Technical Service Information

RE4R01A REPEATED PLANETARY FAILURE

Figure 1

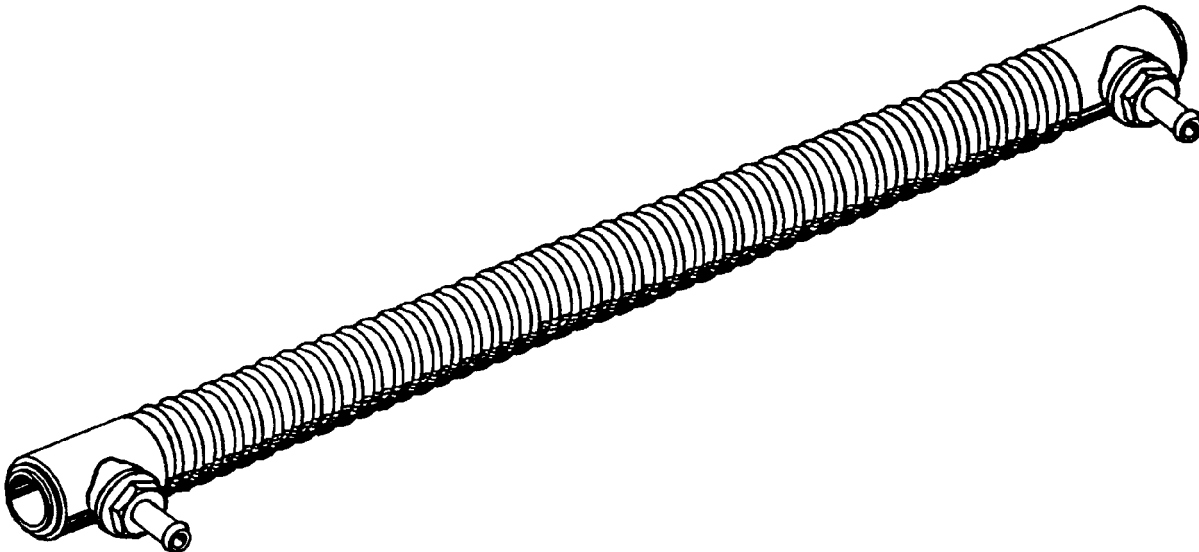
COMPLAINT: RE4R01A transmissions found in Nissan Pathfinders, 200SX, and 300ZX vehicles may experience repeated planetary failure

CAUSE: Most Nissan vehicles have what is known as a "Fin Type" cooler. This type cooler becomes easily restricted, causing poor cooler flow, and resulting in repeated planetary failure. Cooler line flushing machines CANNOT flush clear this type of cooler.

CORRECTION: In the past the entire radiator needed to be replaced to update the cooling system. Nissan has now made available, under OEM part number 21606-15V25, a spiral cooler replacement kit, so the entire radiator does not require replacement (See Figure 1).

SPIRAL COOLER REPLACEMENT KIT FROM NISSAN

OEM PART NUMBER 21606-15V25
